### APPEAL SUMMARY

**Appeal ID:** 18968

**Project Address:** 2318 NW Vaughn St

**Building/Business Name:** Adidas Action Sports

1 FLOOR PLAN - MAIN LEVEL NEW  
1/16"=1'-0"

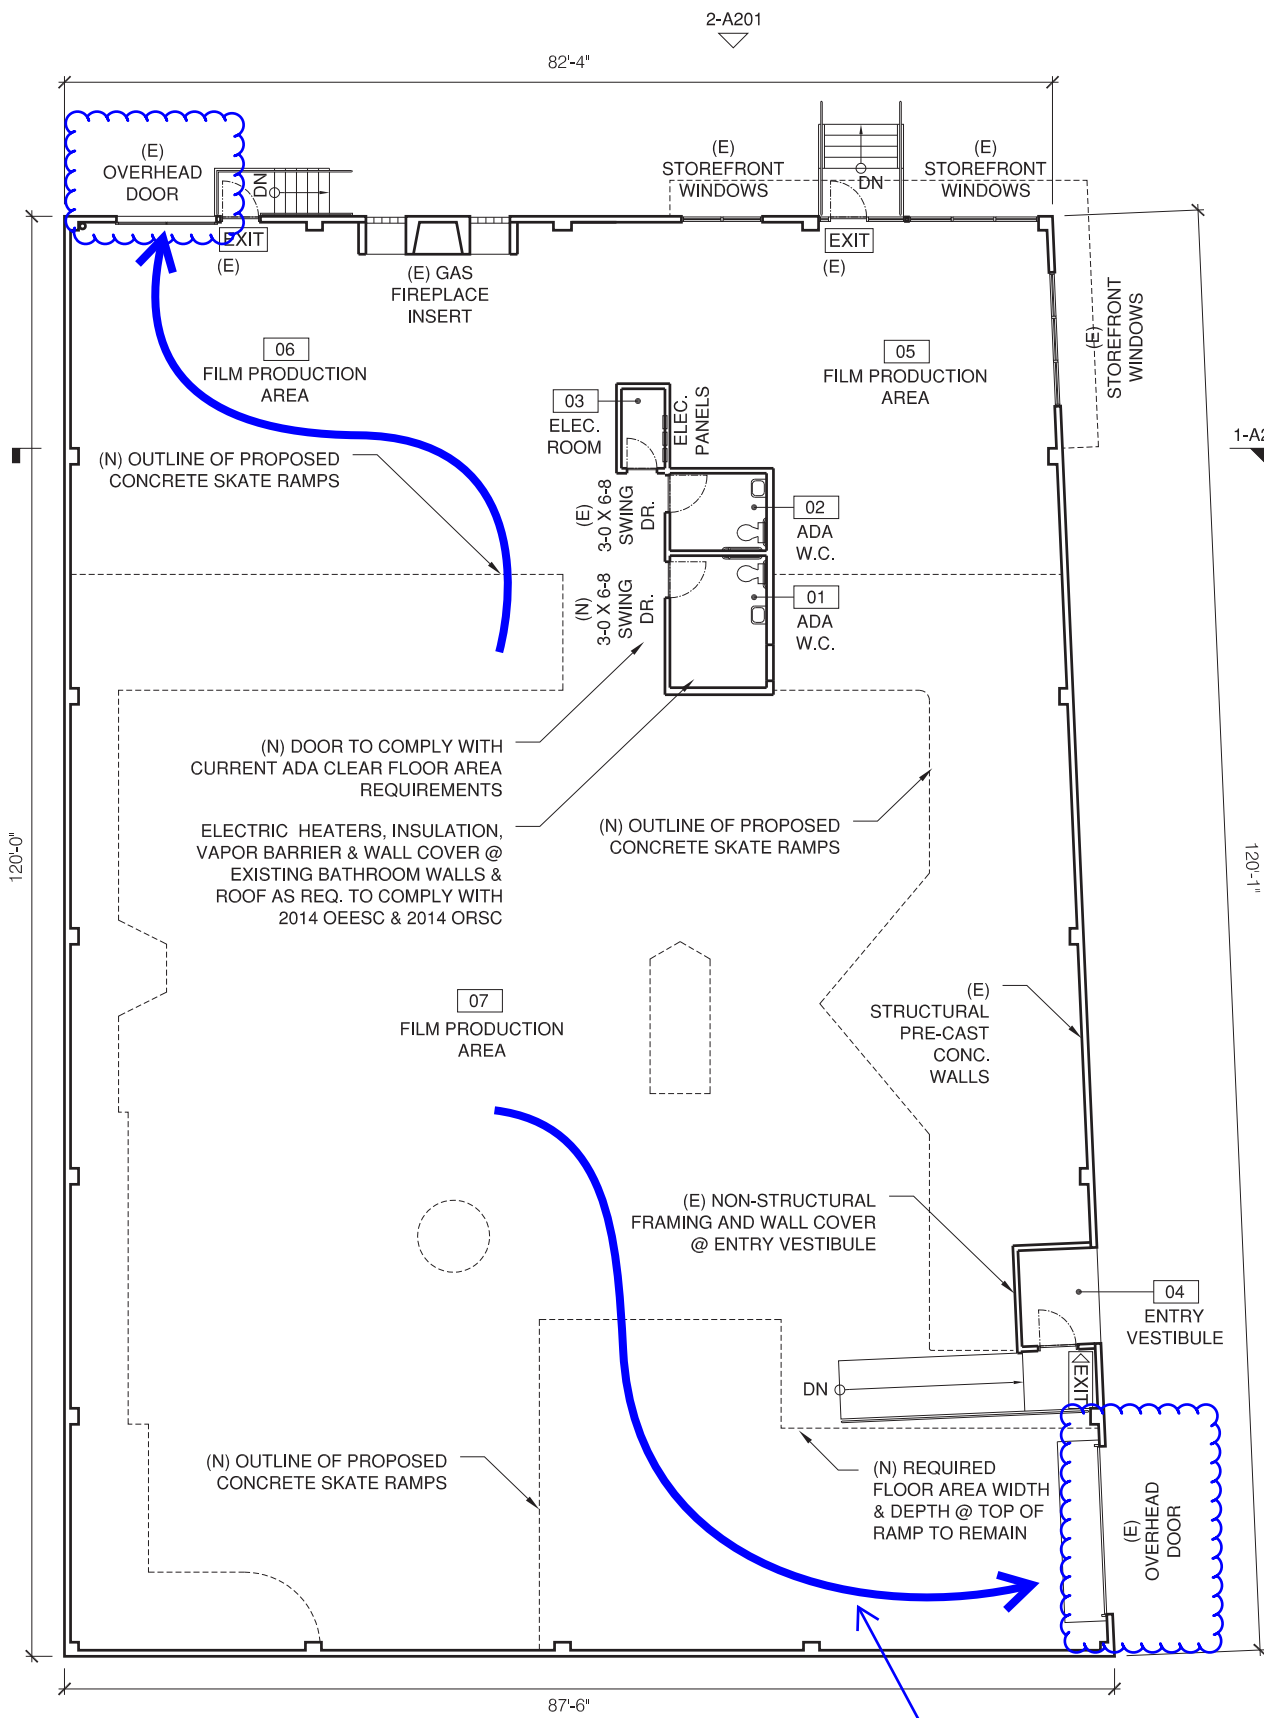
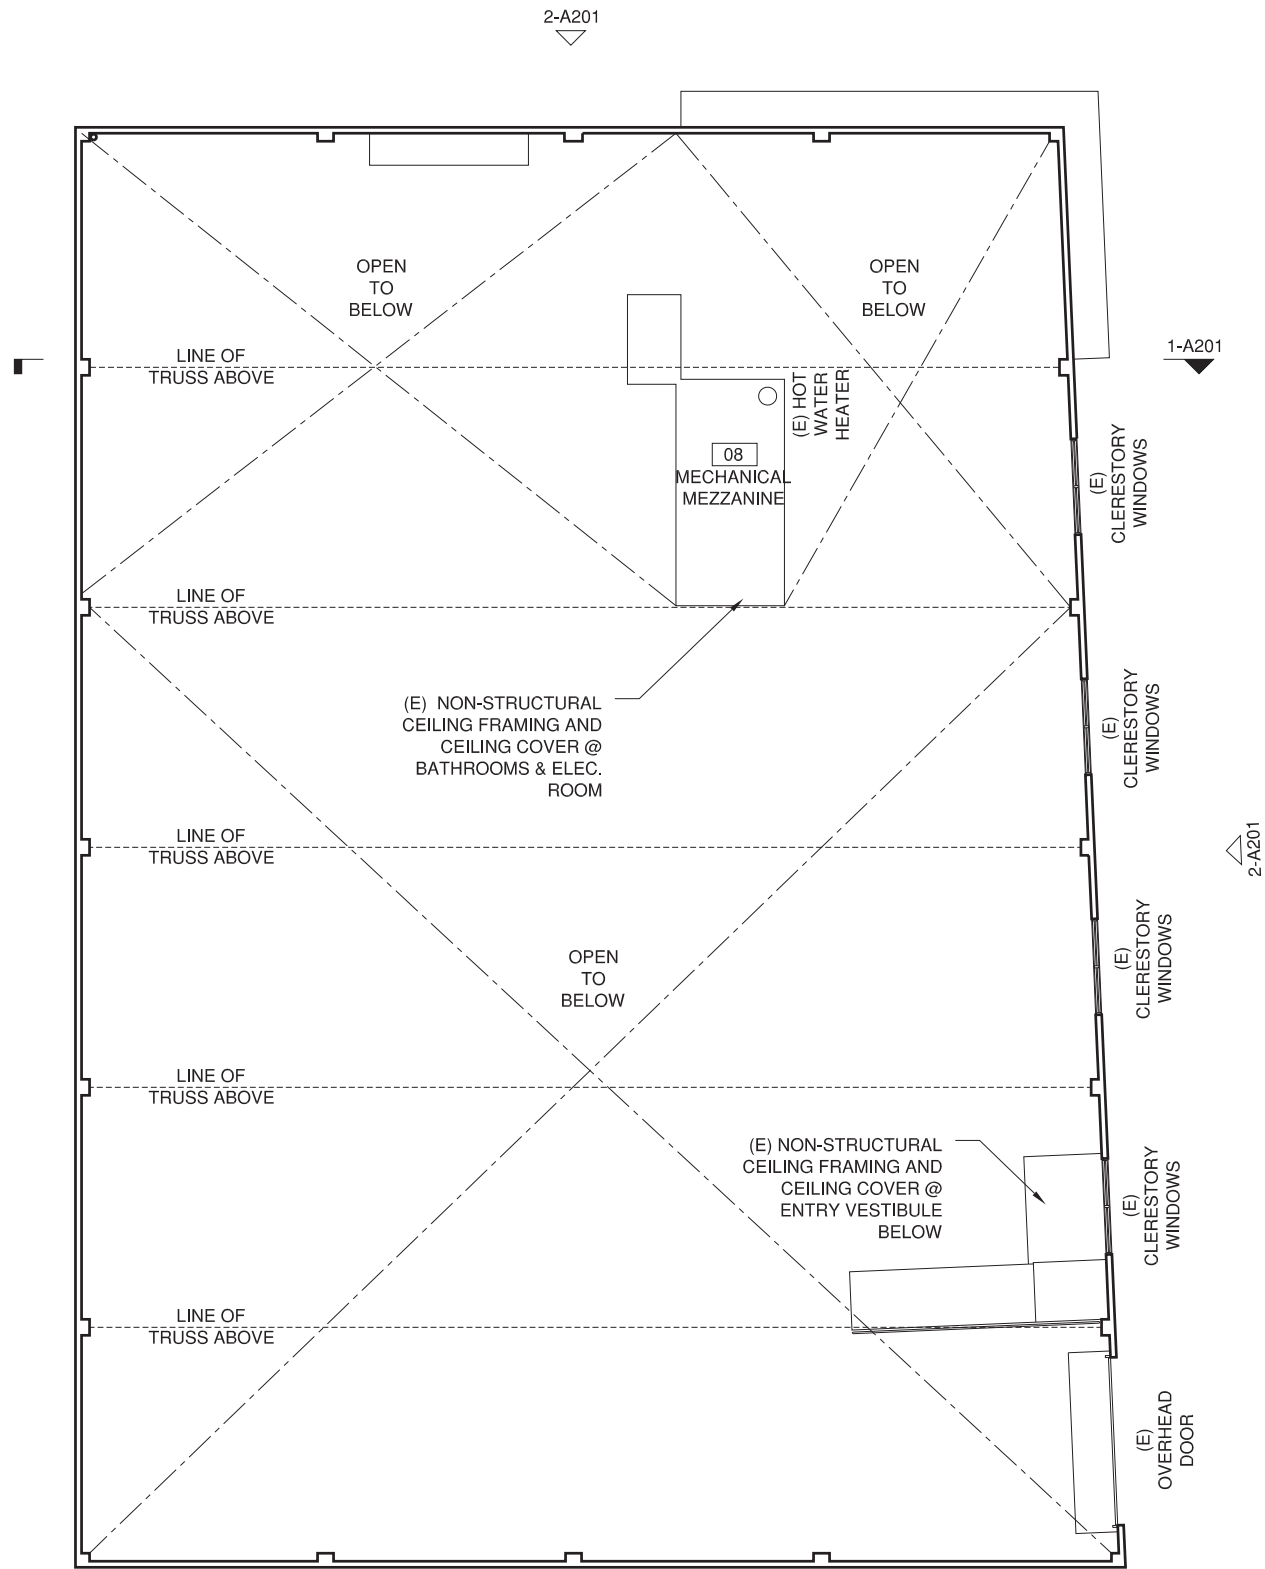
The facility exceeds the prescriptive opening area requirements of §903.2.11.1 on the north side of the building facing NW Vaughn street. Since the building is more than 75 feet deep between north and south walls, it is required to have openings on adjacent wall. Openings are provided on the east side, which faces NW 23rd Avenue. The total area of the openings provided on this side also exceed the mandated area and the 50 ft spacing requirement. Two of the openings also satisfy the 44-inch max sill restriction, while four others are located higher, approximately 10' -9" above adjacent grade and approximately 9'-6" above the interior floor level. Refer to the attached drawings for proposed openings – Floor plan A102, Exterior Wall Elevations A201 & A202.

Products of combustion  
vent through overhead  
doors

**Omission of fire fighter access openings in existing building: Granted as proposed.**

The Administrative Appeal Board finds that the information submitted by the appellant demonstrates that the approved modifications or alternate methods are consistent with the intent of the code; do not lessen health, safety, accessibility, life, fire safety or structural requirements; and that special conditions unique to this project make strict application of those code sections impractical.

2 ELEVATION - NORTH EXISTING  
1/8"=1'-0"

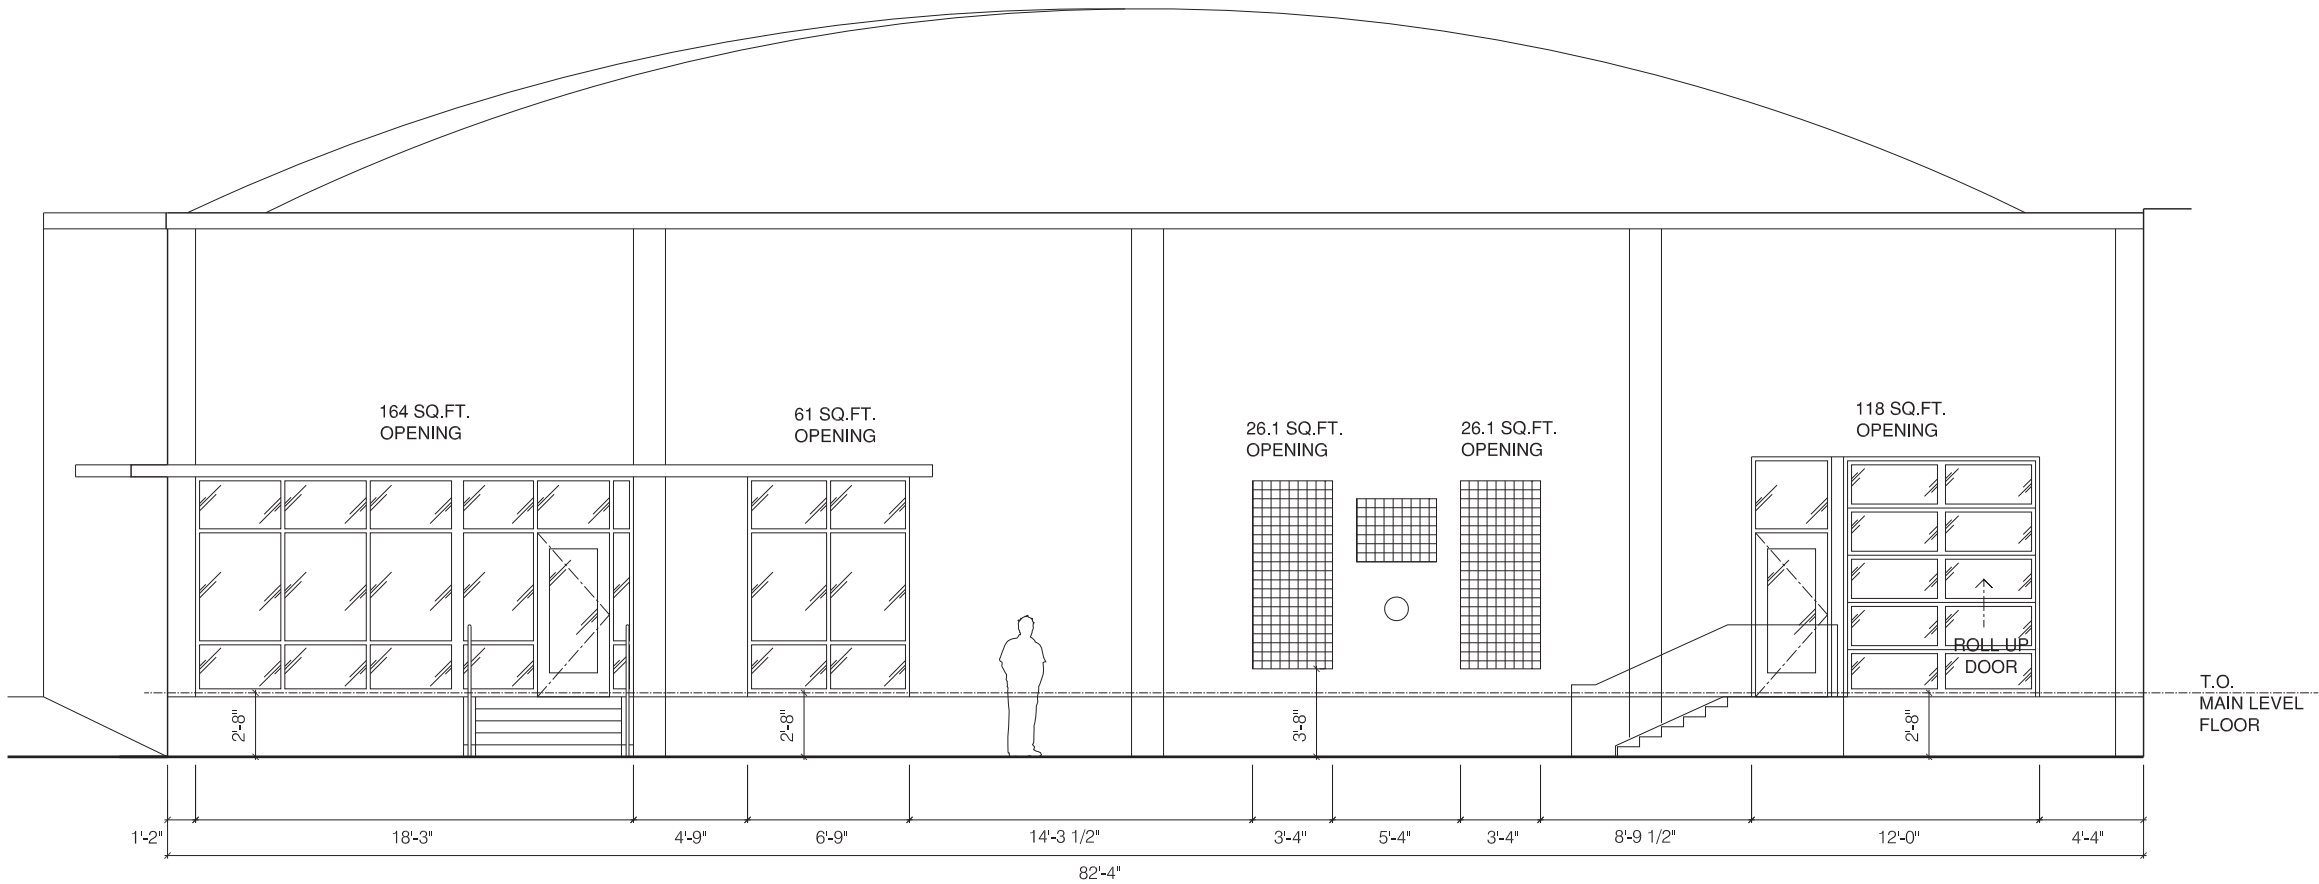
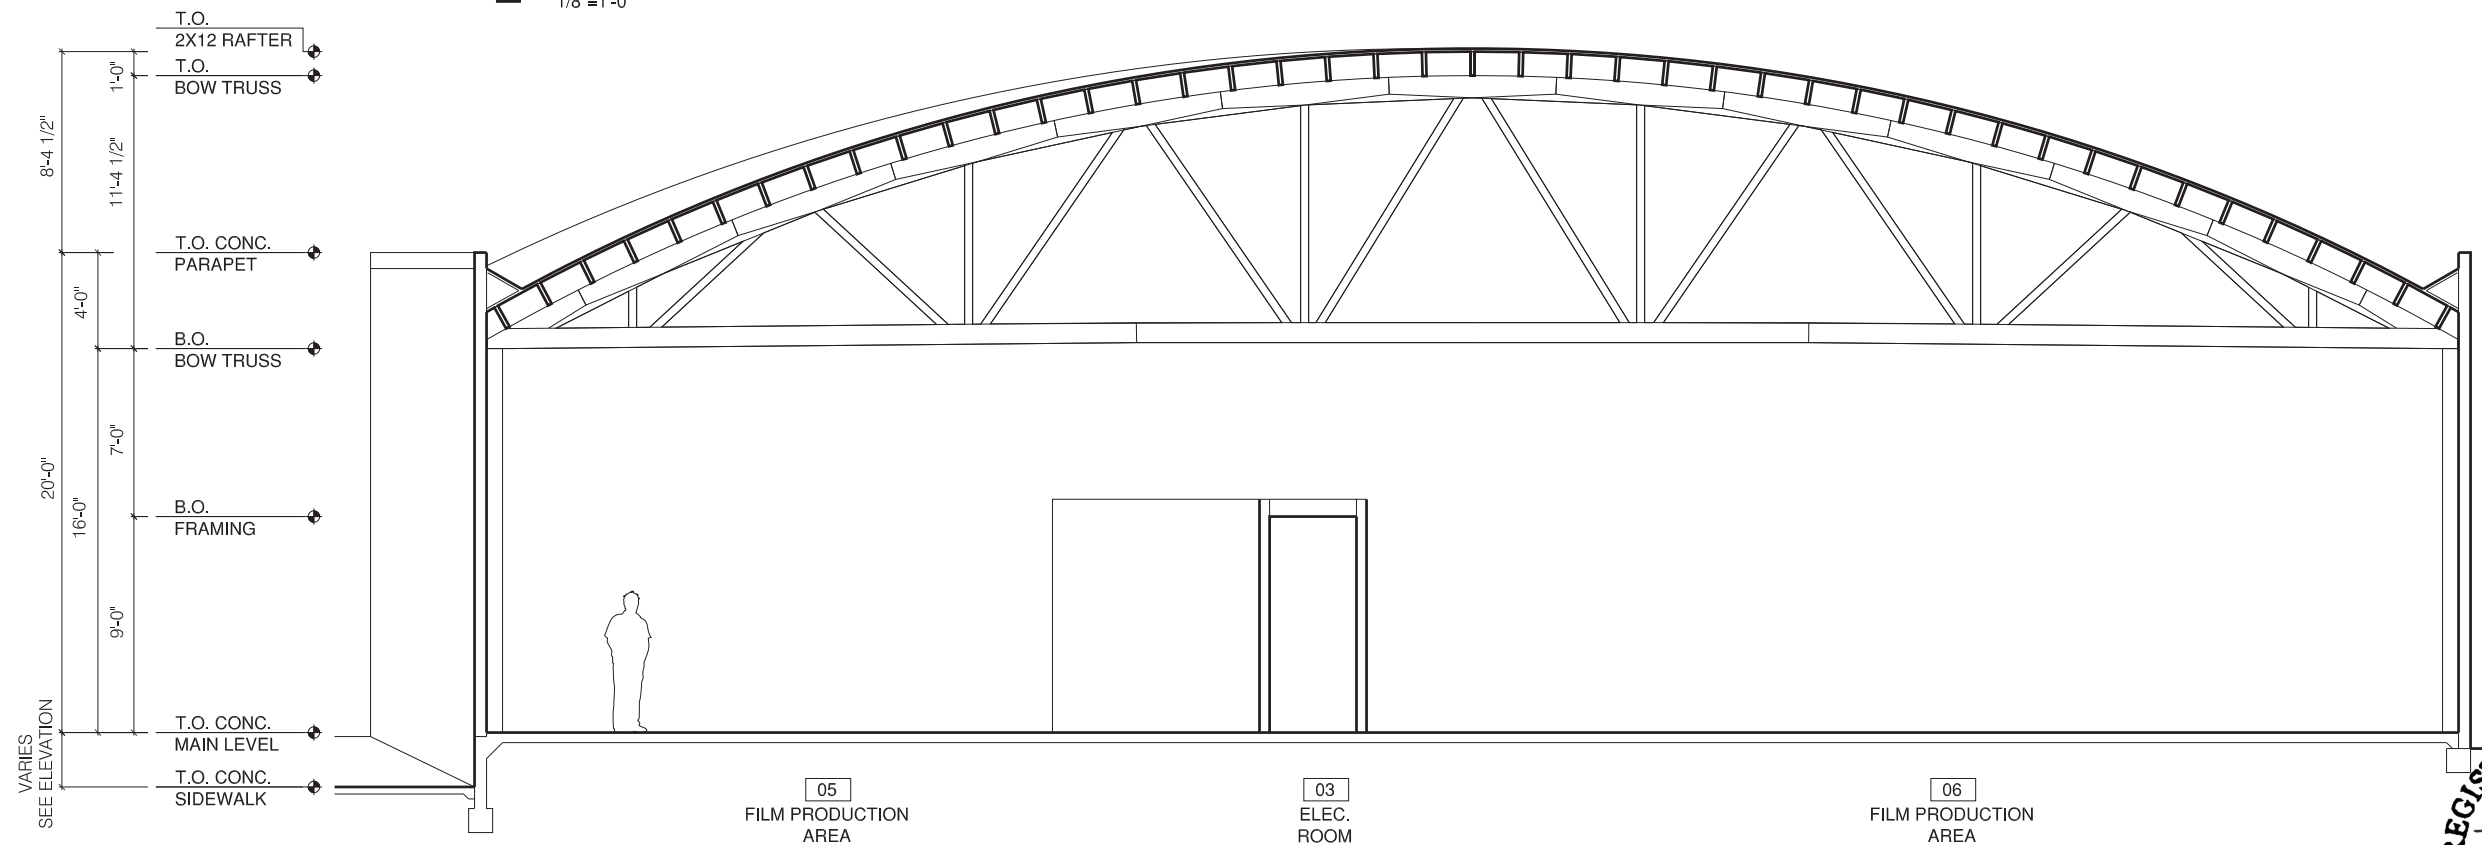
On the north side the fire department has direct access from the Vaughn street, with plenty of storefront glass windows, including two man-doors and one glass paneled garage-door type. The total area of openings provided is 343 sf (excluding glass block at existing fire place), while the prescriptive requirement is 40 sf minimum. Therefore, the proposal exceeds the requirement by 303 sf.

**1** ELEVATION - EAST      EXISTING  
1/8"=1'-0"

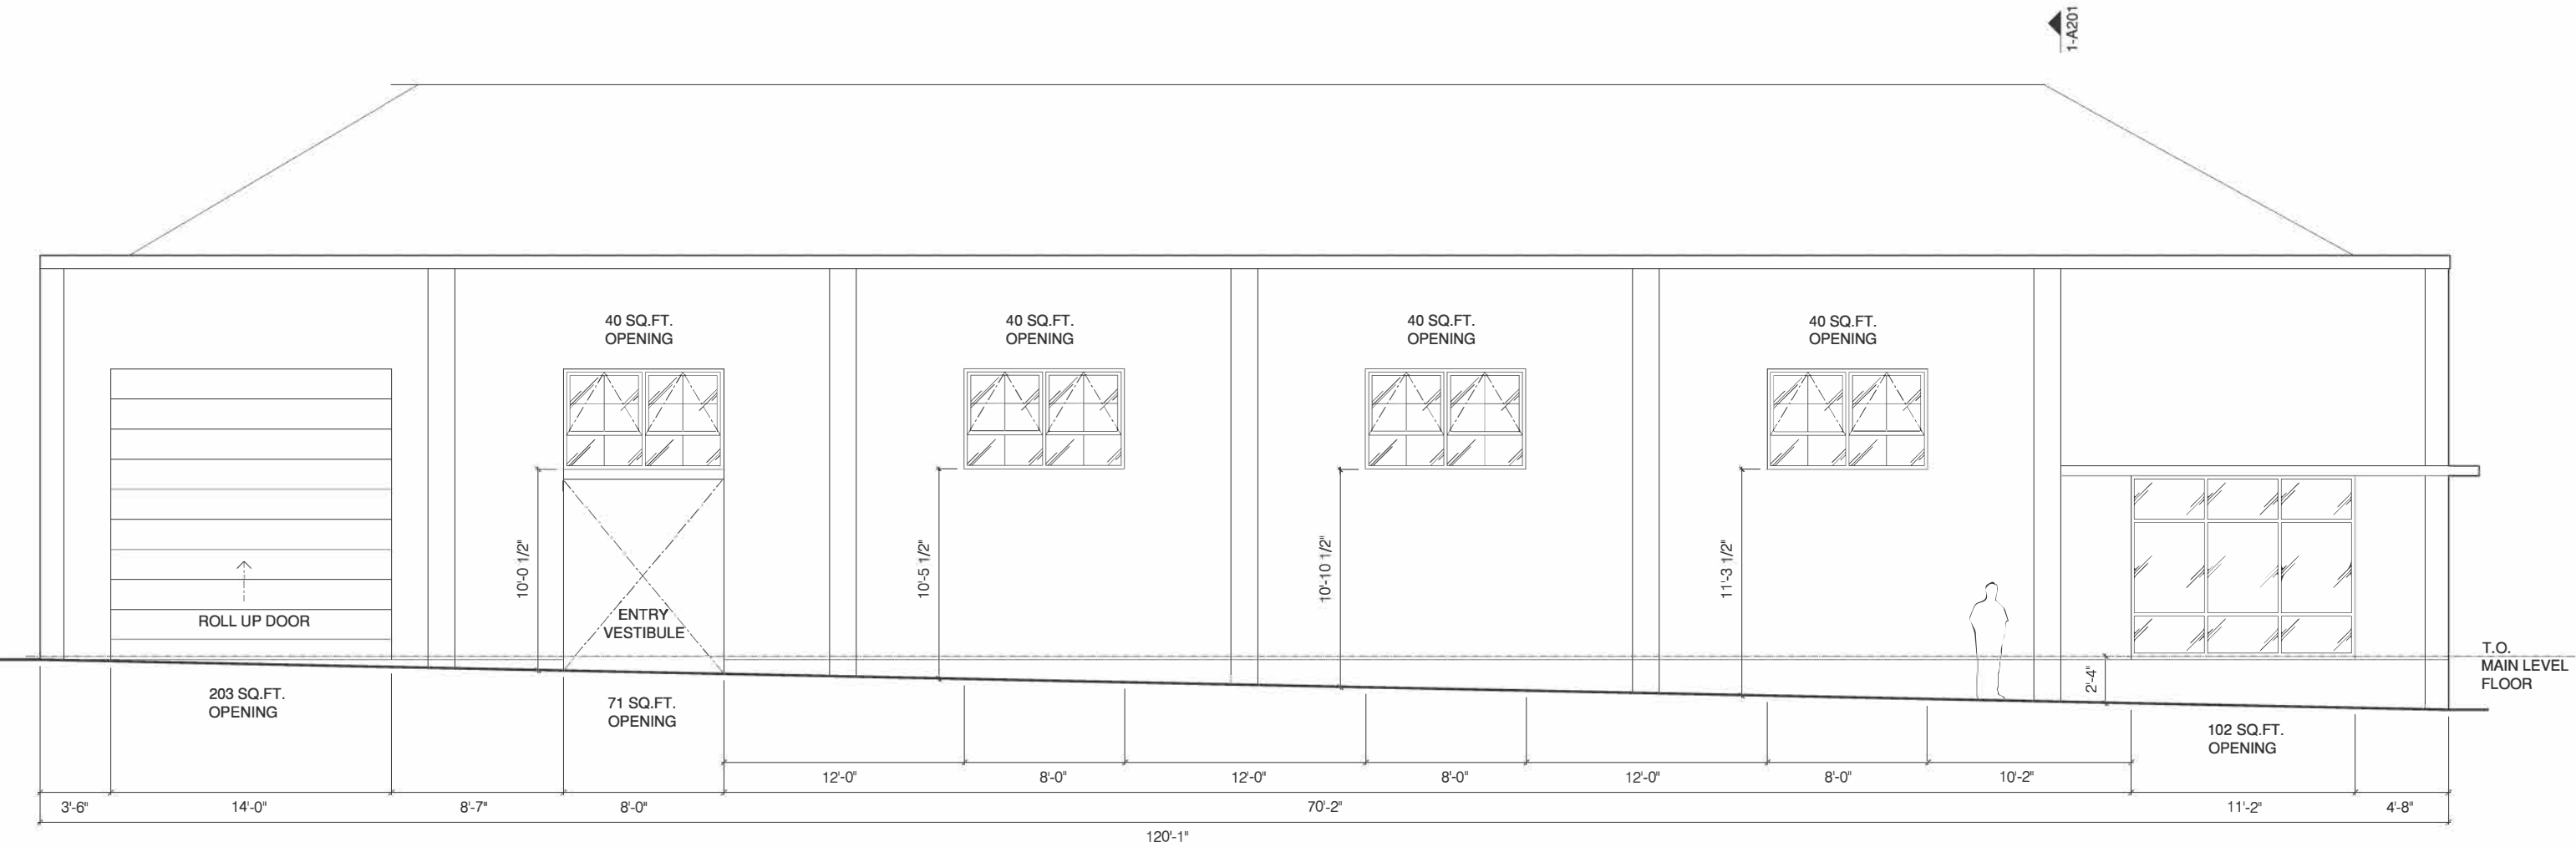
The east side includes one 203 sf roll up door, one 24 sf man door, and one 102 sf storefront that are within the 44-inch sill requirement. The total area of openings provided along the 120 ft long east wall is 486-sf, which exceeds the 60-sf required by code. The three glazed openings that are above the 44" maximum mandated are each 40-sf and located at 9'-6" above floor level. These windows are easily accessed from outside and will allow the venting of combustion products well above the occupiable floor in this high bay space.
